Exhibit 3: Lunt-Fontanne Theater

Exhibit 3B: Architectural Modifications

Exh. 3B Architectural Modifications to Lunt Fontanne Theater

3. LUNT FONTANNE THEATER
LOWER LEVEL WOMEN TOILET ROOM PLAN

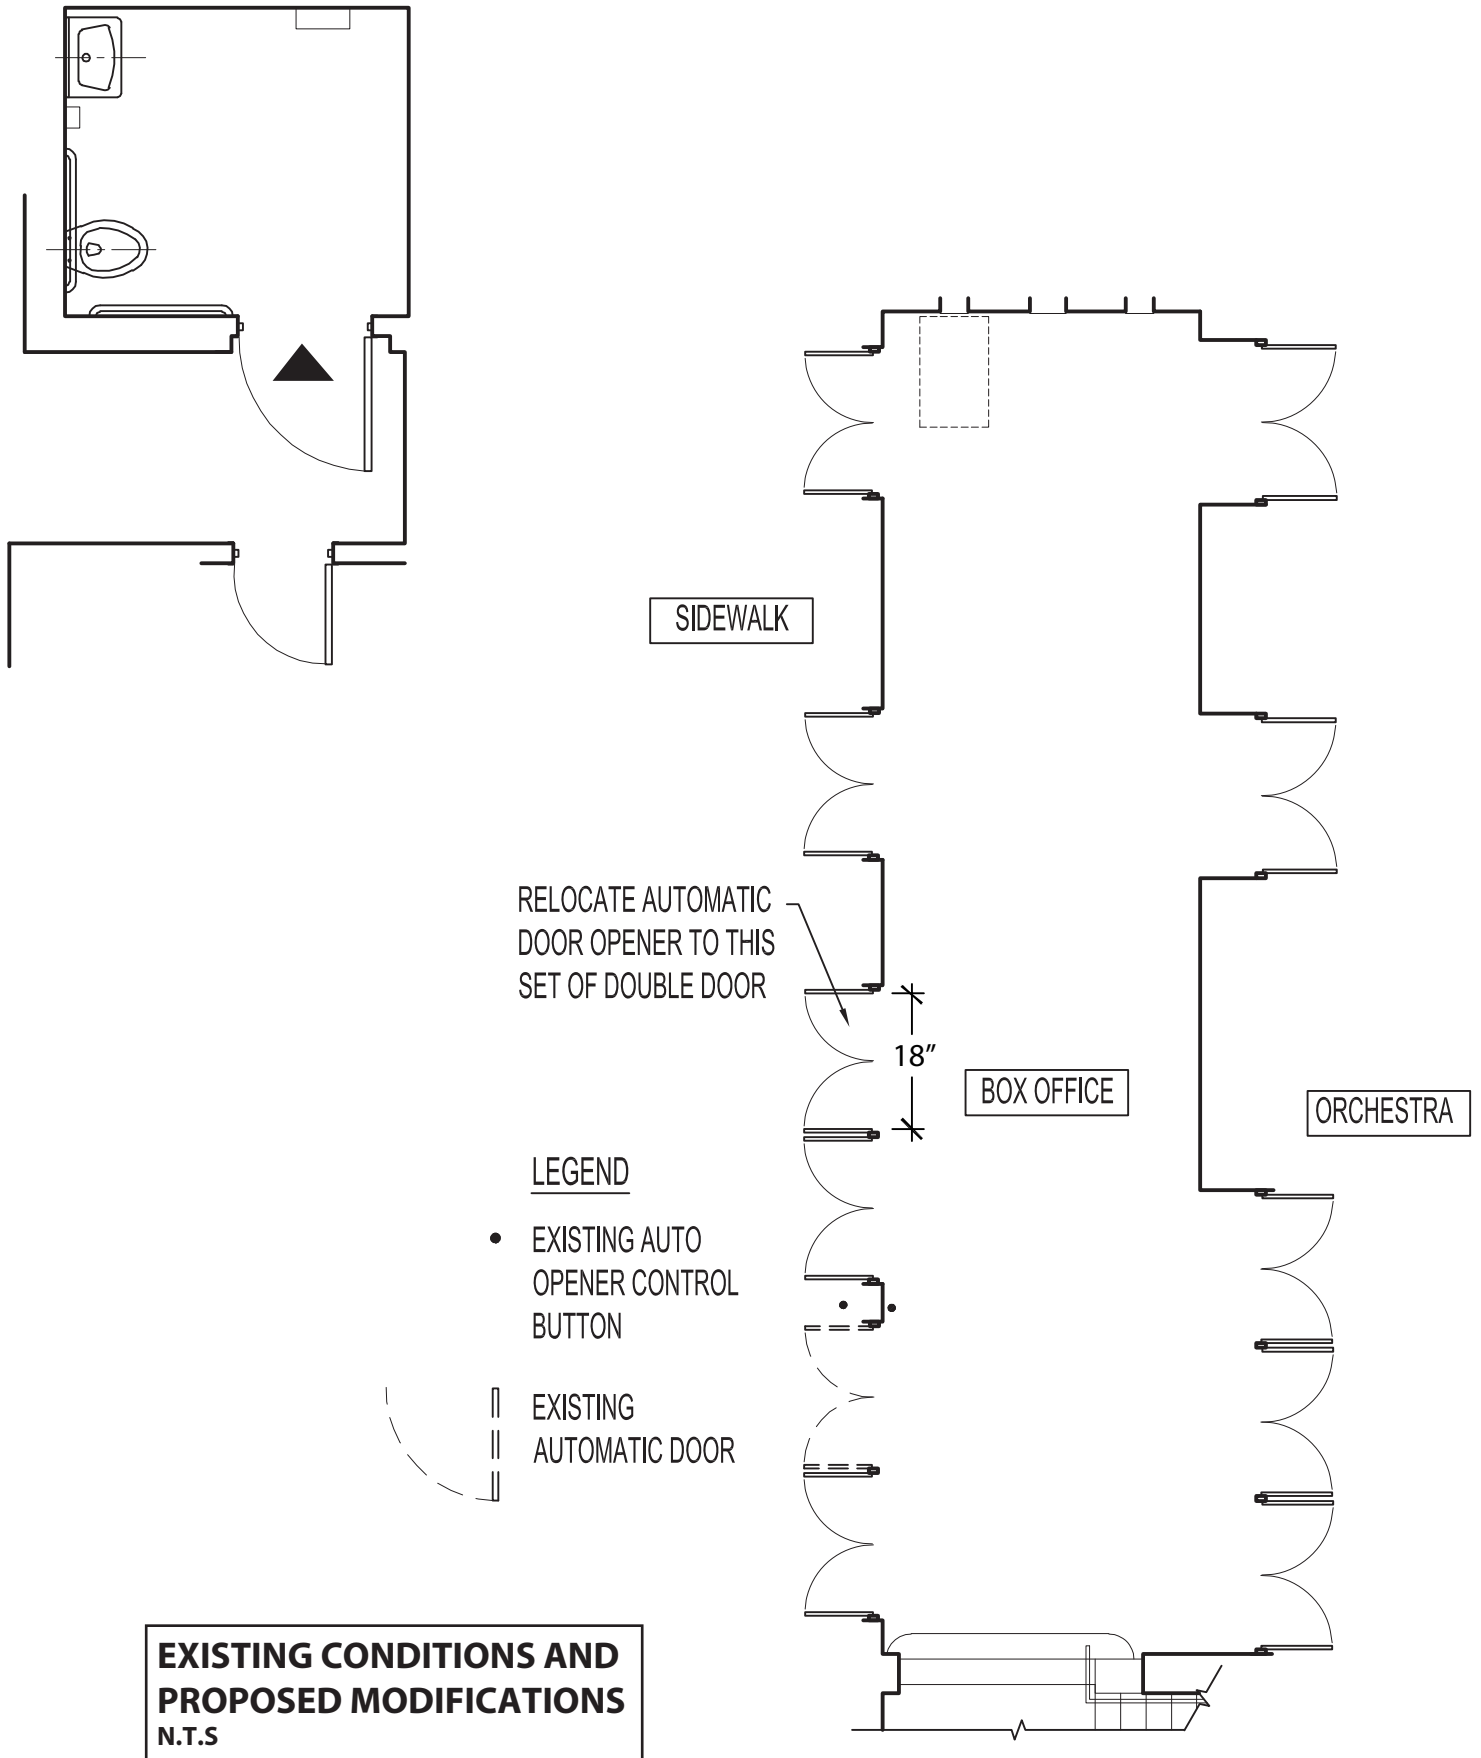
11	Lower Level (Women's Toilet Room)	The door requires 9 pounds of force to open and travels from 70° open to 3" from the latch in 4 seconds.	Closer at non-fire-rated interior door causes door to travel from 70 degrees open to 3" from latch in less than 3 seconds and/or exceeds the maximum force to open (5 lbs).	4.1.3(7)(b) 4.1.3(7)(c) 4.1.3(7)(d) 4.13.10 4.13.11	Defendant will test and monitor door closer for compliance.
12	Lower Level (Women's Toilet Room)	In one section of the toilet room, the low ceiling in a corner projects 34" at 72" AFF from the closest cane-detectable element (wall) below it.	Section of low ceiling is less than 80" AFF above circulation path.	4.4.1 4.4.2 Fig. 8(a-e)	Defendant will install cane detectable element.

Line #	Location Description	Existing Condition	Barrier Description	1991 Standards Reference	Architectural Modification
13	Lower Level (Women's Toilet Room)	The lavatory countertop is 33" AFF with no knee space provided.	The counter mounted lavatory provides less than the required knee clearance (29" minimum AFF at front, 27" minimum AFF at 8" deep).	4.1.3(11) 4.19.2 4.19.3 4.22.6 Fig. 31	Compliant lavatory has been provided during course of investigation.
14	Lower Level (Women's Toilet Room)	The coat hook is mounted at 65" AFF in ambulatory stall.	The coat hook in the ambulatory stall is above the 48" or 54" max reach height (depending on approach).	4.1.3(11) 4.2.5 4.2.6 4.22.7 4.25 4.27.3 Fig. 5 Fig. 6 Fig.38	Compliant coat hook mounting height has been provided during course of investigation.
15	Lower Level (Women's Toilet Room)	The double roll toilet paper dispenser in the ambulatory stall is mounted 29" to 39" from the rear wall.	The double roll toilet paper dispenser in the ambulatory stall is mounted more than 36" from the rear wall.	4.1.3(11) 4.1.6(1)(b) 4.1.6(2) 4.16.6 4.22.4 4.22.7 Fig. 29(b) Fig. 30(d)	Defendant will provide compliant mounting height of toilet paper dispenser.

16	Lower Level (Women's Toilet Room)	There is no rear grab bar in the accessible stall. The standard accessible stall is 66" wide x 61" deep.	There is no rear grab bar in the accessible stall.	4.1.3(11) 4.1.6(1)(b) 4.1.6(1)(c) 4.1.6(1)(k)(ii) 4.1.6(2) 4.17.6 4.22.4 Fig. 29 Fig. 30(a&a-1)	Defendant will install new rear grab bar.
17	Lower Level (Women's Toilet Room)	The coat hook is mounted at 65" AFF in ambulatory stall.	The coat hook in the standard accessible stall is above the 48" or 54" max reach height (depending on approach).	4.1.3(11) 4.2.5 4.2.6 4.22.7 4.25 4.27.3 Fig. 5 Fig. 6 Fig.38	Compliant coat hook mounting height has been provided during course of investigation.

Line #	Location Description	Existing Condition	Barrier Description	1991 Standards Reference	Architectural Modification
18	Lower Level (Women's Toilet Room)	The toilet paper dispenser in the standard accessible stall is mounted 34" to 44" from the rear wall.	The toilet paper dispenser in the standard accessible stall is mounted more than 36" from the rear wall.	4.1.3(11) 4.1.6(1)(b) 4.1.6(2) 4.16.6 4.22.4 4.22.7 Fig. 29(b) Fig. 30(d)	Compliant mounting height of toilet paper dispenser will be provided.
19	Lower Level (Men's Toilet Room)	Overhead sign but no compliant RLB sign provided.	There is no raised lettering and Braille room identification sign provided at this gender specific multi- user toilet room.	4.1.3(16)(a) 4.30.1 4.30.4 4.30.5 4.30.6	Compliant signage will be provided.
20	Lower Level (Men's Toilet Room)	Non-fire rated door requires 8½ pounds of force to open and travels from 70° open to 3" from the latch in 5 seconds.	Closer at nonfire-rated interior door causes door to travel from 70 degrees open to 3" from latch in less than 3 seconds and/or exceeds the maximum force to open (5 lbs).	4.1.3(7)(b) 4.1.3(7)(c) 4.1.3(7)(d) 4.13.10 4.13.11	Defendant will test and monitor door closer for compliance.

Exhibit 3C: Seating

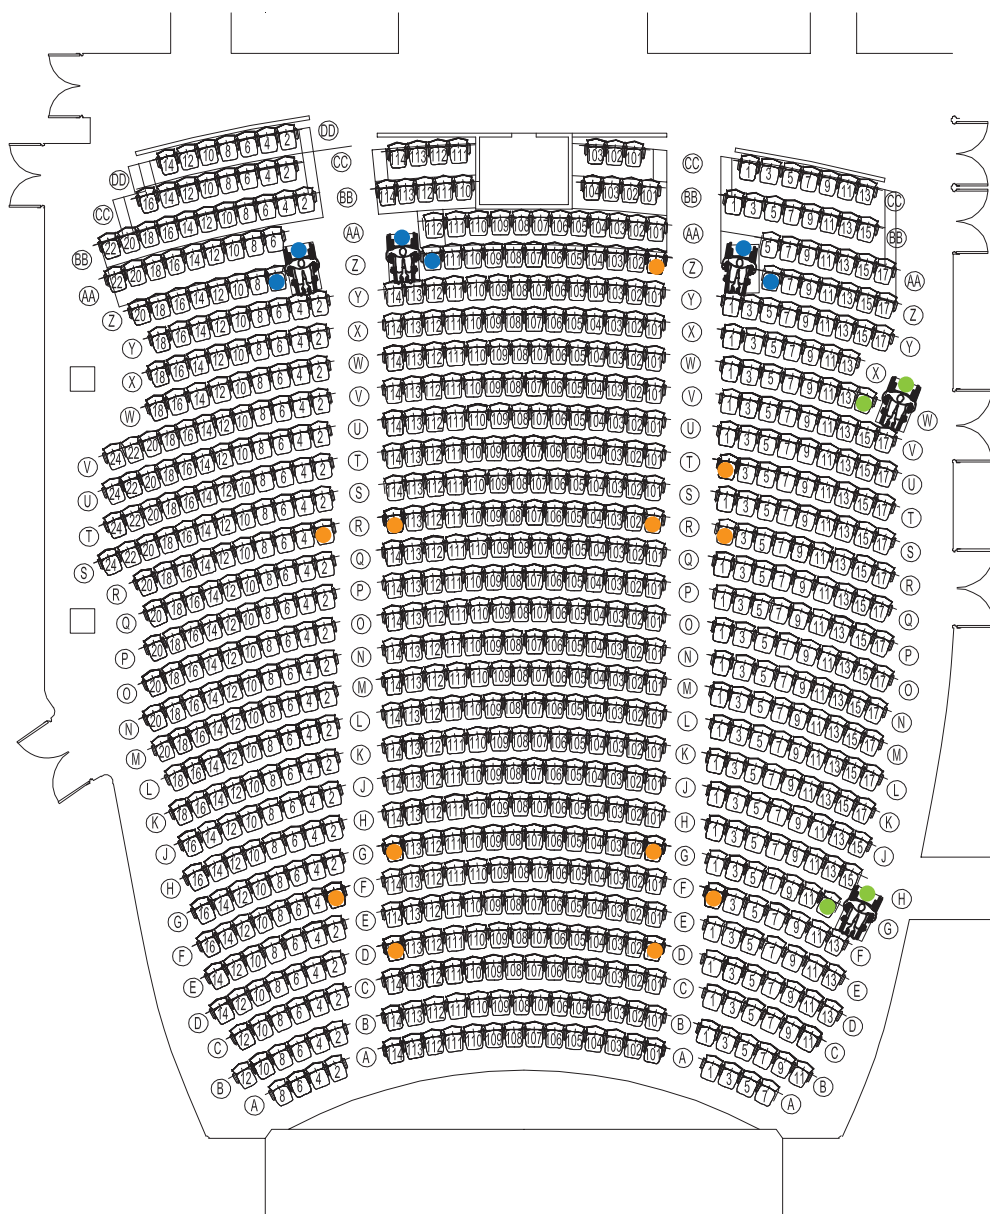
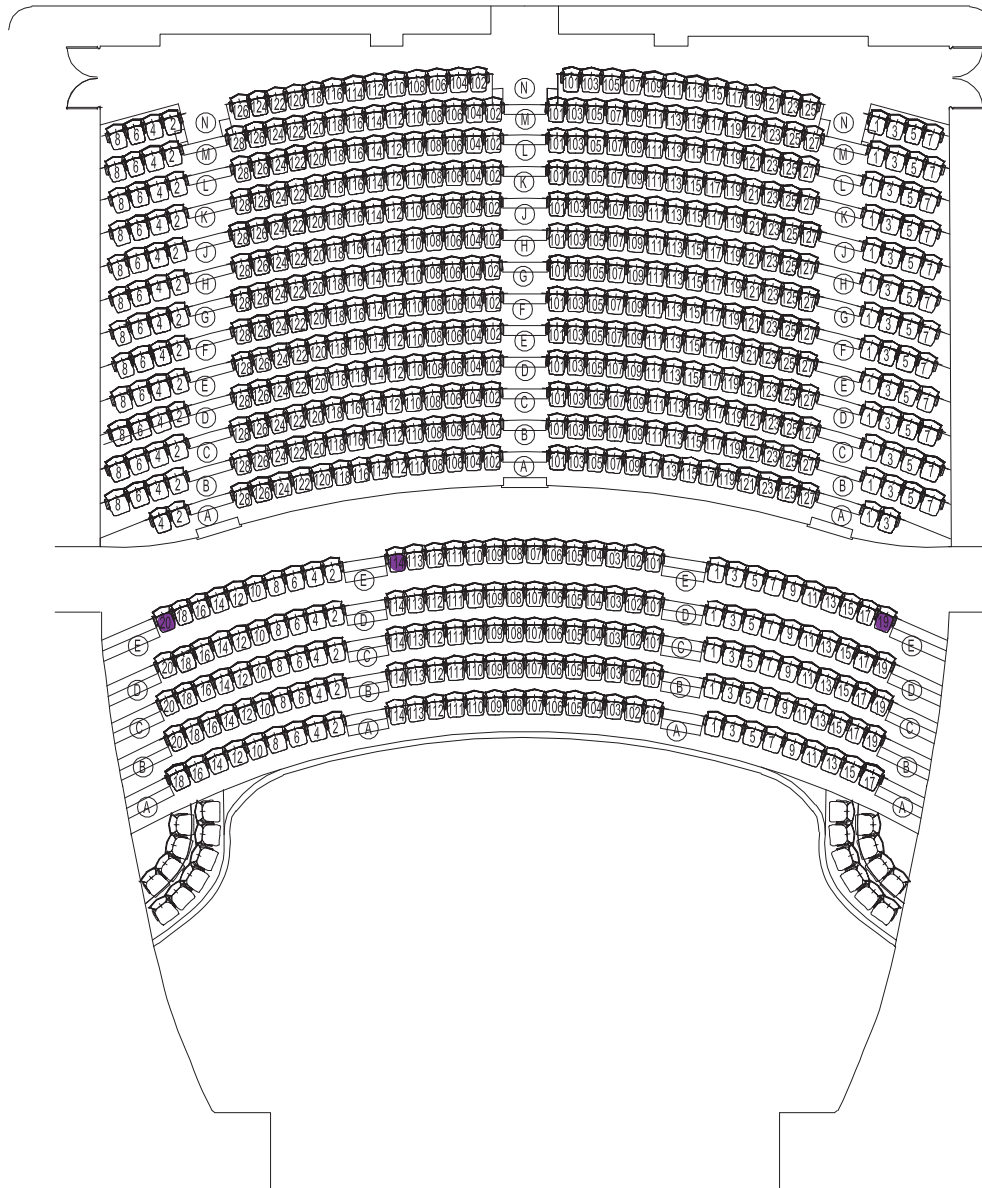
1. Nederlander shall maintain the two existing wheelchair and companion seating locations on the Orchestra level: at G15 and W17, with G13 and W15 being companion seating locations.

2. Nederlander shall add three new wheelchair seating locations on the Orchestra level, at Z1/Z3/AA1/AA3; at Z113/Z114/AA113/AA114; and at Z2/Z4/AA2/AA4, with companion seating locations at Z5, Z112, Z6.

3. Nederlander shall maintain the twelve aisle transfer seating locations on the Orchestra level at D101, D114, F1, F2, G101, G114, R114, T1, R2, Z101, R101, R1 and add three new aisle transfer seating locations on the Mezzanine Level at E20, E114 and E19.
